REGIONAL REVIEW FINDING

Name of Proposal: Bowen Homes Redevelopment DRI 4036

Description: A DRI review of a proposal to construct a mixed-use project with 37 single-family units, 1,963 multi-family units, 60,000 SF of retail space, 20,000 SF of office space, and 25,000 SF of community center space on a 74-acre site of the former Bowen Homes housing development of of Donald Hollowell Parkway and James Jackson Parkway in the City of Atlanta.

OVERALL SITE PLAN

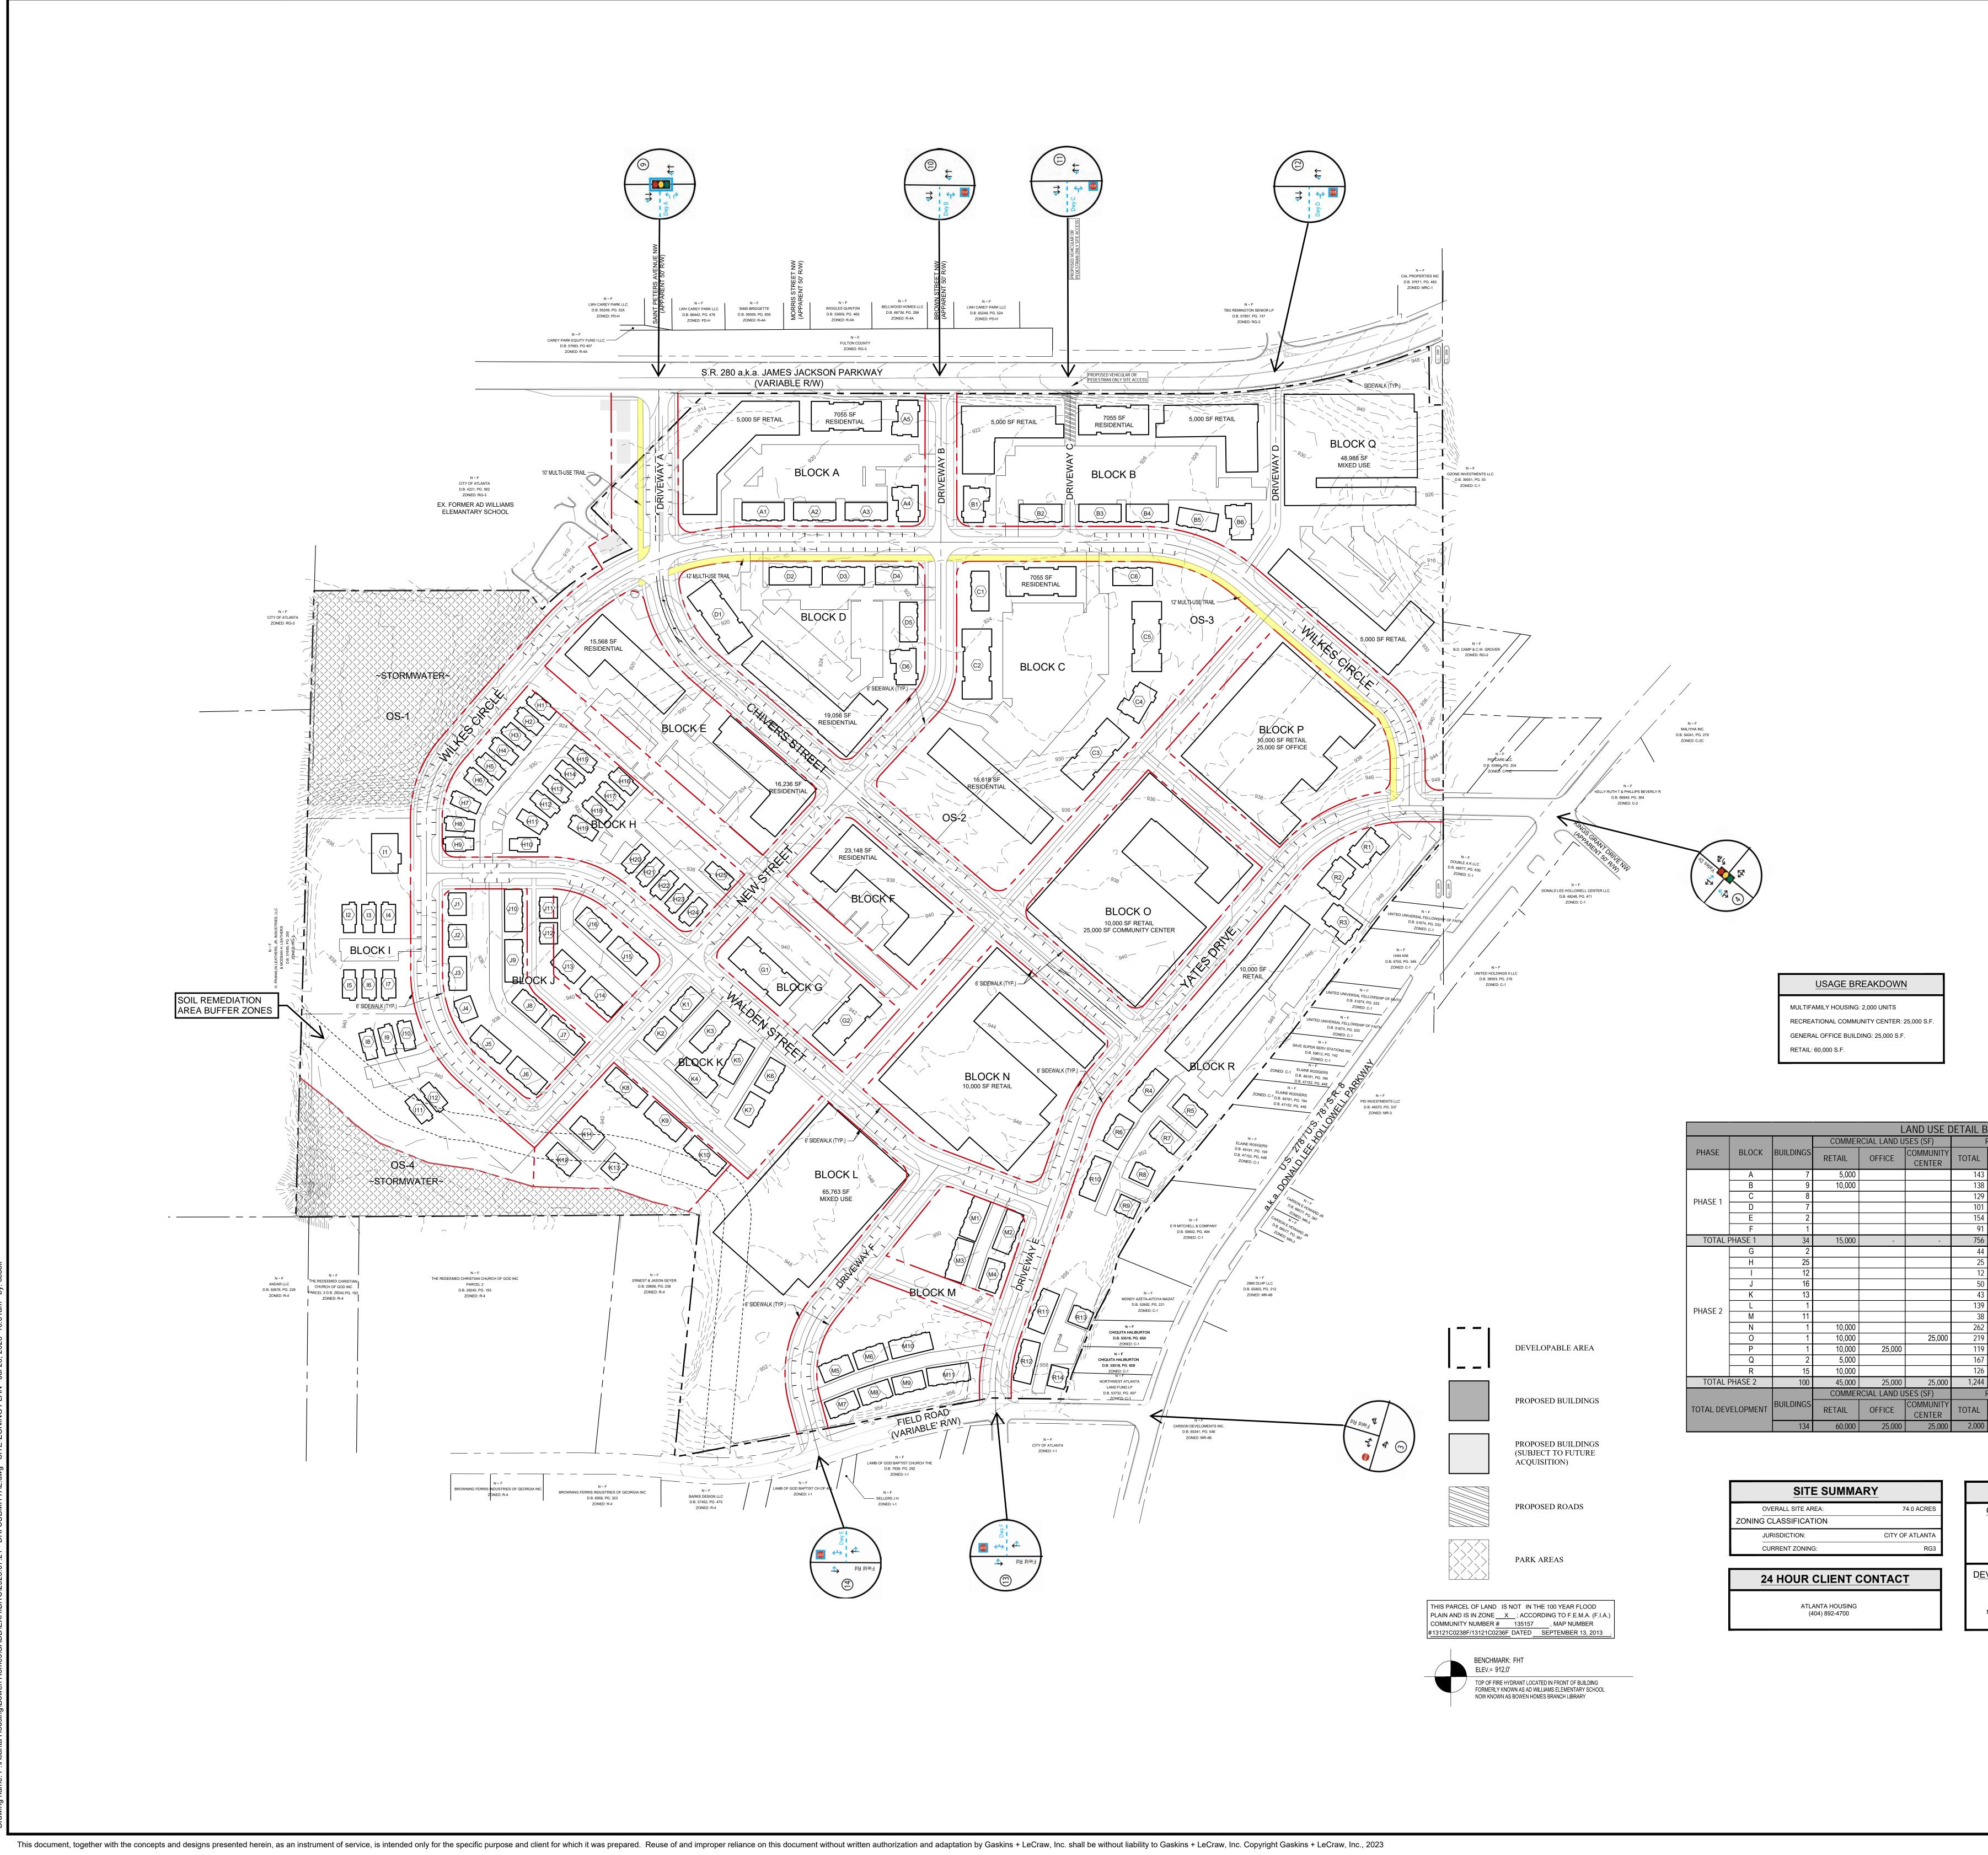
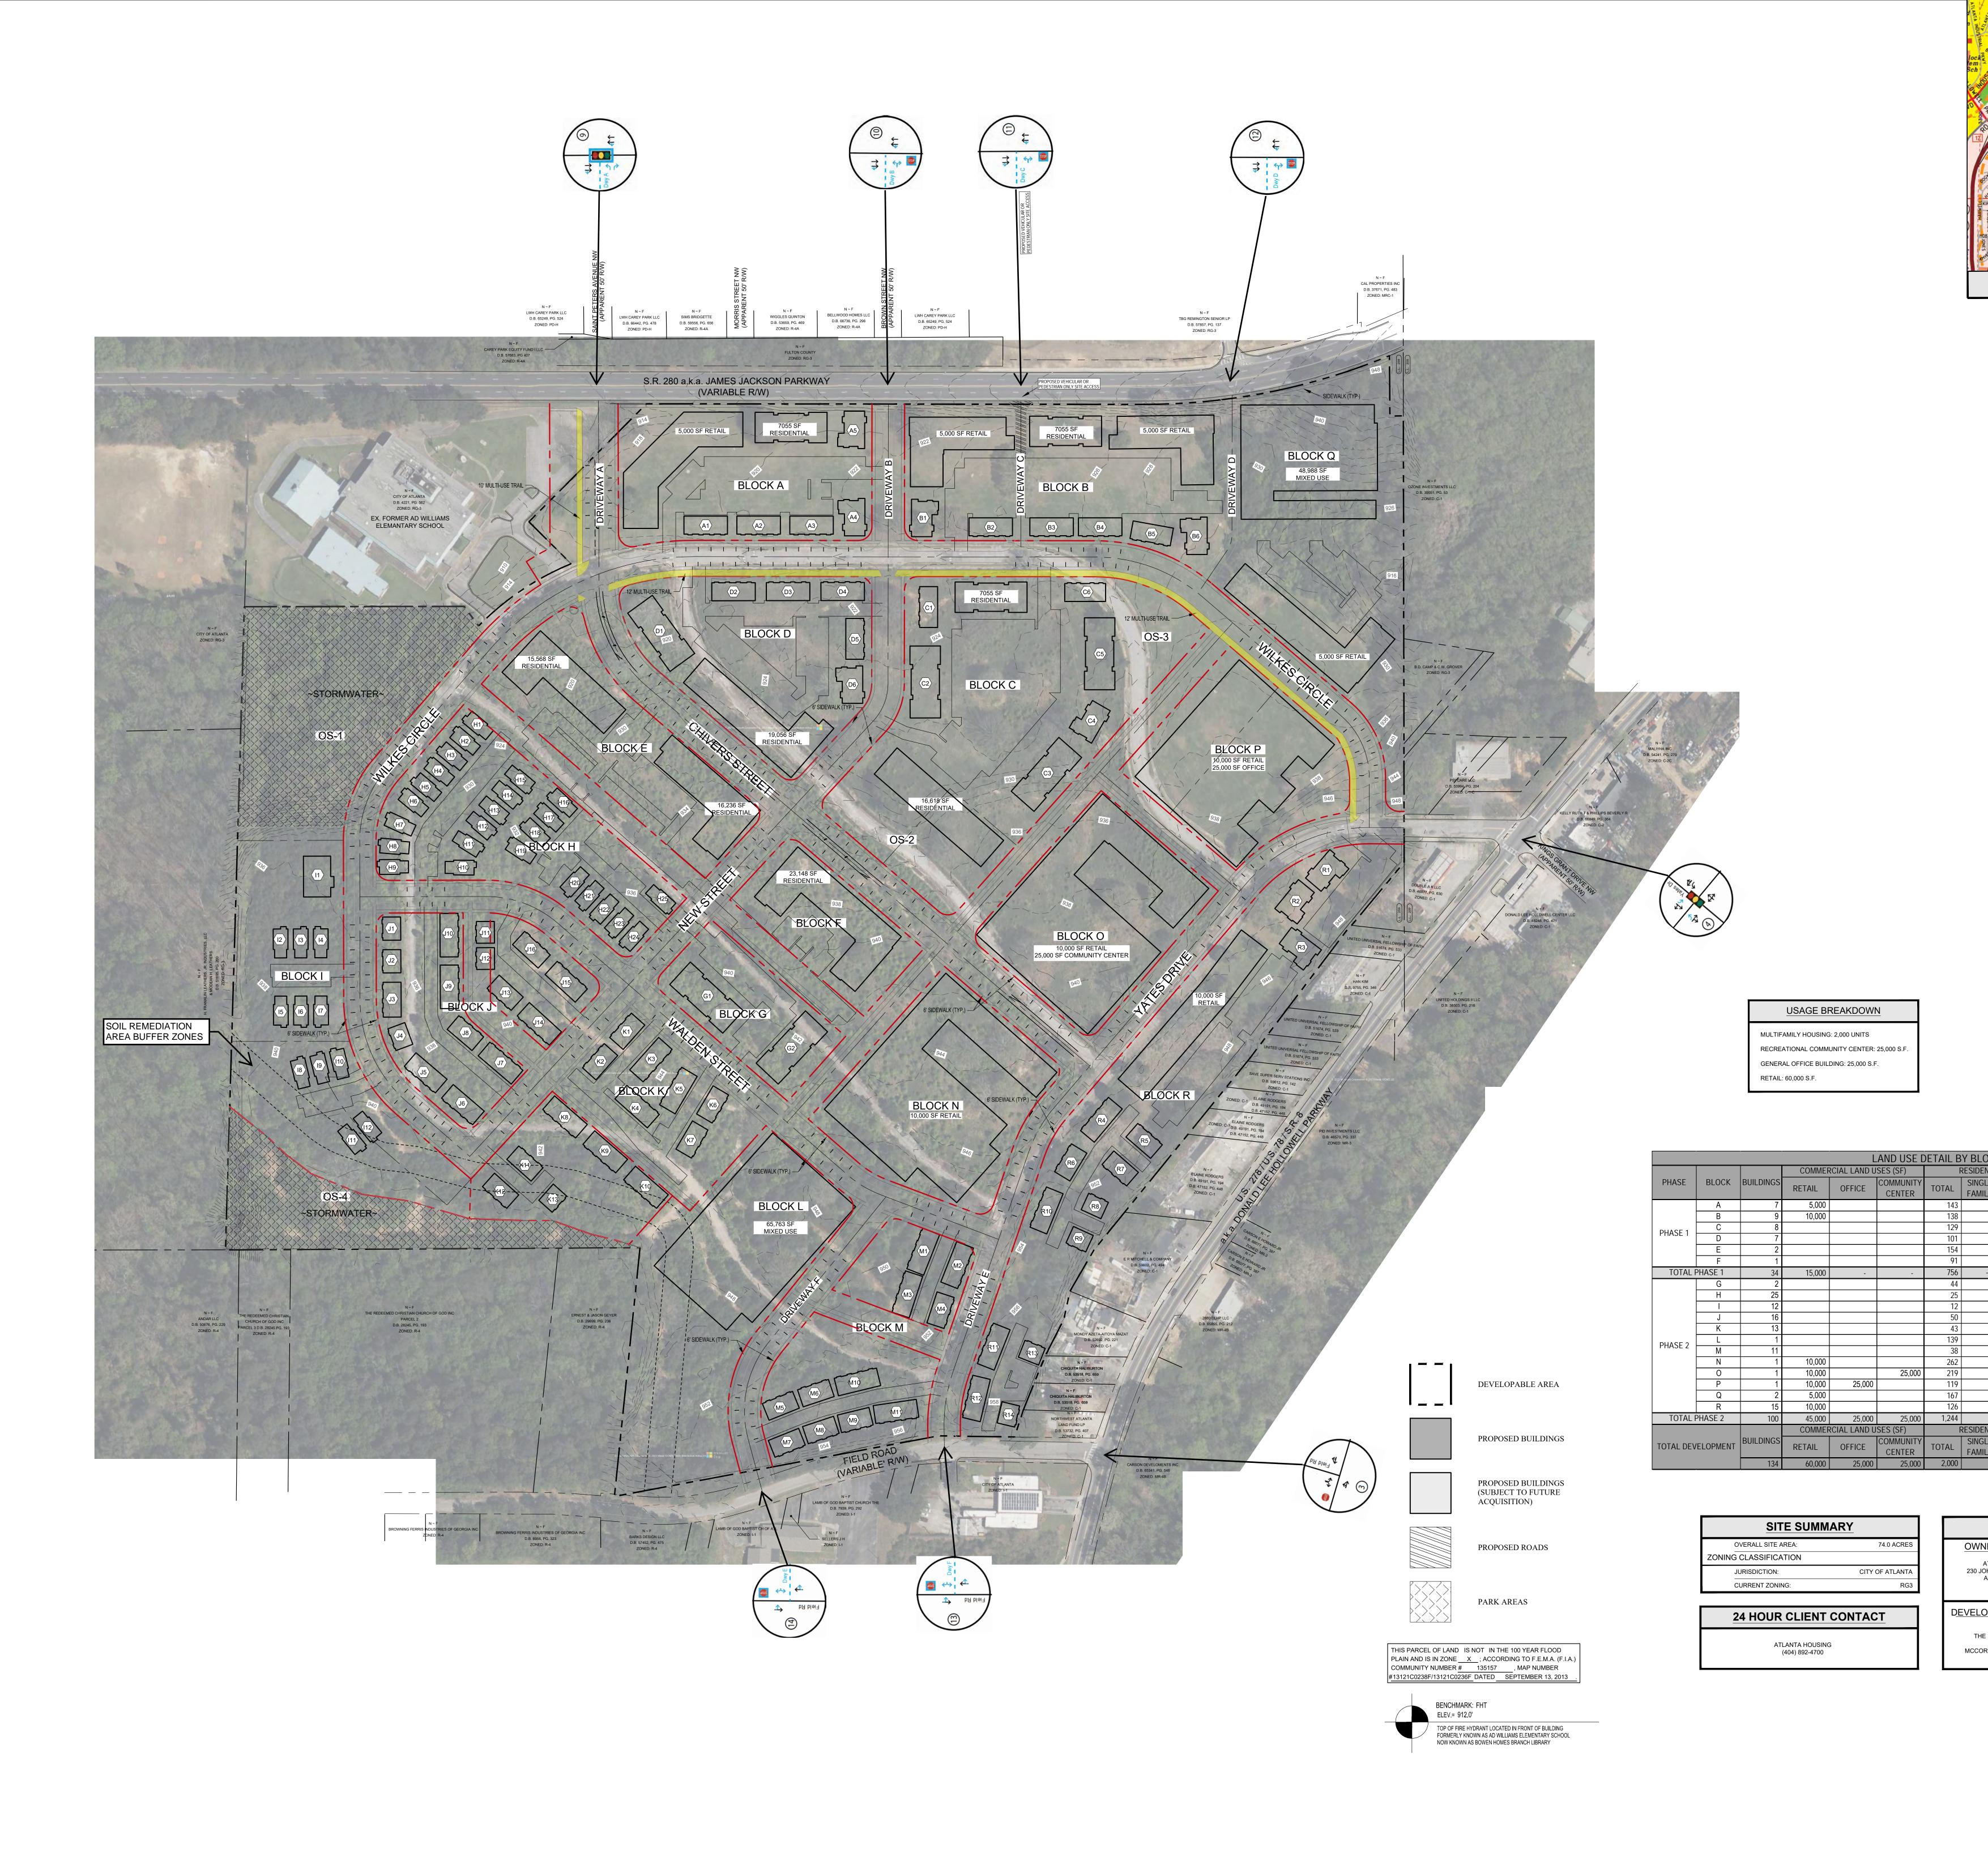
The project could be further aligned with Maturing Neighborhood policies by providing more defined greenspace and park areas.

The project's provision of a robust sidewalk network and multi-use internal trail are supportive of regional multi-modal transportation policies; fine tuning the final trail route could provide enhanced pedestrian connectivity.

Plans do not appear to identify EV charging spaces or bicycle parking spaces; optimal amounts of both would be supportive of regional multi-modal and transportation electrification policies.

The project site plan does not indicate any parks or playgrounds which are key requirements for a mixeduse project of this size. The final plan will need to include adequately-sized and well designed parks and recreation areas.

The project's provision of a robust sidewalk network and multi-use internal trail are supportive of regional multi-modal transportation policies. The route of the proposed multi-use trail appears to skirt the center of the development. A more central route along Chivers Street would provide much stronger connectivity to the full project. Connection of the project to a larger regional trail network would substantially enhance its multi-modal transportation connectivity.

A total of 1,783 parking spaces are proposed in a mix of on-street and structured parking facilities. Plans do not appear to identify EV charging spaces or bicycle parking spaces; provision of optimal amounts of both would be supportive of regional multi-modal and transportation electrification policies. Care should be taken to ensure that the constructed development provides an interconnected, functional, clearly marked and comfortable pedestrian experience on all driveways, paths, entrances, and parking areas. To the maximum extent possible, new driveways and intersection corners where pedestrians will cross should be constructed with minimal curb radii to reduce speeds of turning vehicles and decrease crossing distances for pedestrians.

linear storm water park connects through the site east to west, creating green infrastructure to reduce flooding." but these elements are not shown on the site plan. Inclusion of these measures would be highly supportive of regional stormwater and environmental policies.
